You will find enclosed a copy of Service Bulletin S07MC regarding the tie rod ends on certain 2006-08 model year Blue Bird Vision (BBCV) buses.

Hendrickson Tie Rod Ends

MODELS AFFECTED: All Blue Bird Visions (BBCV)

ISSUE

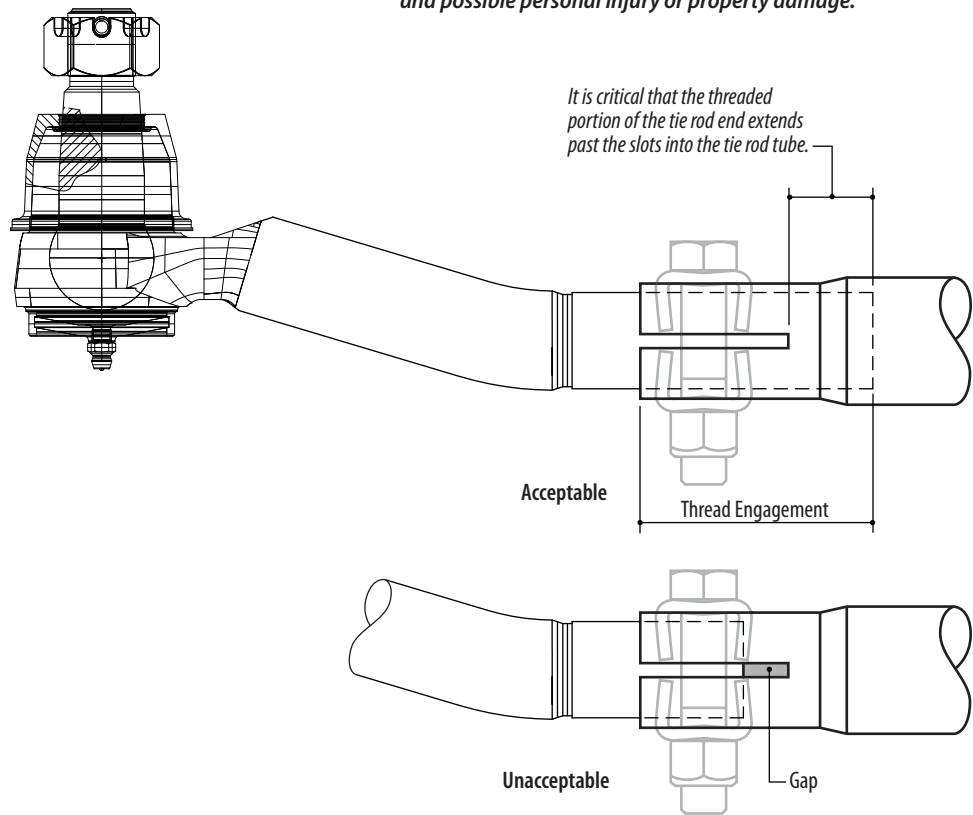
The tie rod assembly on Hendrickson front axles used on all Blue Bird Visions has undergone two changes since the introduction of the Vision. The changes were not reflected in Blue Bird part numbers because the tie rod assemblies are interchangeable. However, the First Generation tie rod ends are not interchangeable with the Second or Third Generation tie rod ends, resulting in different Hendrickson assemblies for individual subparts and assemblies. Blue Bird published S0705 Hendrickson Tie Rod Ends on May 14, 2007 to identify these changes and provide part numbers for our customers. It is possible, however, that a First Generation tie rod end (which had a long cross tube) may have been installed into a Second or Third Generation (which has a short cross tube) on chassis built after July 2005.

Inspect all Tie Rod Ends and/or Tie Rod End/Cross Tube assemblies, installed or purchased since July 2005. Inspect tie rod end thread engagement into cross tube. If threads do not extend past the end of the slot in the cross tube or if any gap exist between the tie rod end and the end of the cross tube slot, contact your Blue Bird Service Parts Representative for replacement parts.

WARNING The threaded portion of the tie rod end must extend past the slots in the tie rod cross tube, failure to do so can cause component to fail causing loss of vehicle control and possible personal injury or property damage.

First Generation Tie Rod Ends

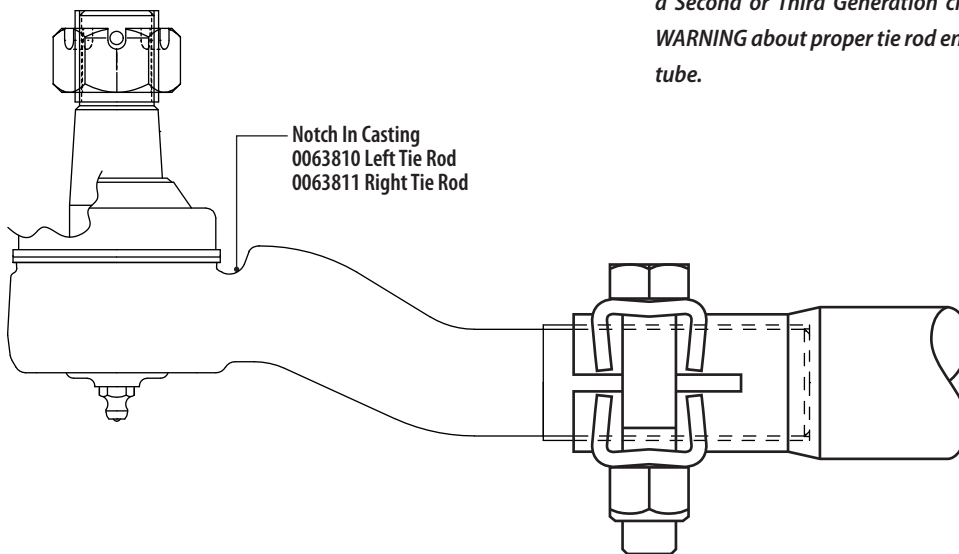
First generation tie rod ends were used on Blue Bird Visions from its launch date to mid July, 2005. This tie rod end can be identified by a “notch” in the casting very near the rubber bushing. The replacement part numbers for this style tie rod end are 0063810 (Left) and 0063811 (Right).

Per Hendrickson Technical Bulletin SEU-0223 Tie Rod End Replacement Kits Revision B dated May 2007, the tie rod assembly and tie rod ends for these parts are obsolete and are no longer available. The entire tie rod assembly must be replaced. Per Hendrickson Technical Bulletin, Hendrickson Tie Rod End part number 66699-001 (Blue Bird 0094365) replaces Hendrickson Tie Rod End part number 59948-001, 59948-002 or 59948-006. Per Hendrickson Technical Bulletin, Hendrickson Tie Rod End part number 66699-003 (Blue Bird 0118467) replaces Hendrickson Tie Rod End part number 59948-004 or 59948-005. Note: The tie rod part number is located on the tie rod cross tube. Select the correct replacement for your vehicle.

WARNING DO NOT use a First Generation tie rod end with a Second or Third Generation cross tube. Refer to Hendrickson **WARNING** about proper tie rod end thread engagement into cross tube.

Second Generation Tie Rod Ends

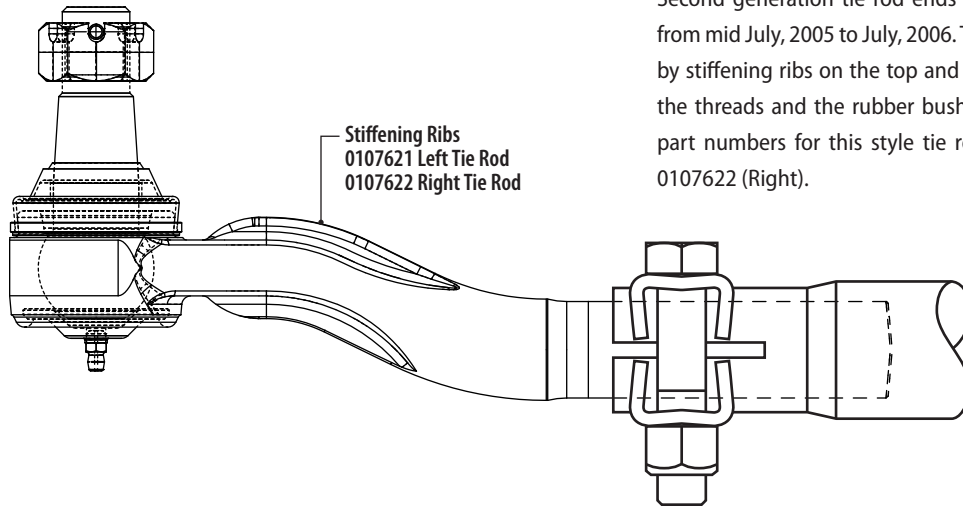
Second generation tie rod ends were used on Blue Bird Visions from mid July, 2005 to July, 2006. This tie rod end can be identified by stiffening ribs on the top and bottom of the casting between the threads and the rubber bushing. The Blue Bird replacement part numbers for this style tie rod end are 0107621 (Left) and 0107622 (Right).

Third Generation Tie Rod Ends

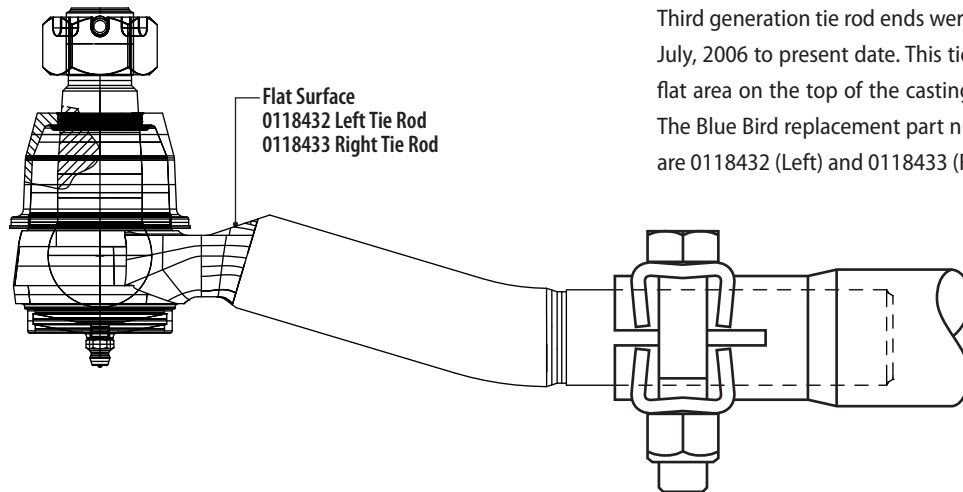
Third generation tie rod ends were used on Blue Bird Visions from July, 2006 to present date. This tie rod end can be identified by a flat area on the top of the casting very near the rubber bushing. The Blue Bird replacement part numbers for this style tie rod end are 0118432 (Left) and 0118433 (Right).

The tie rod ends for the Second and Third Generations are interchangeable even though visually they are different shapes and are from different manufacturers.
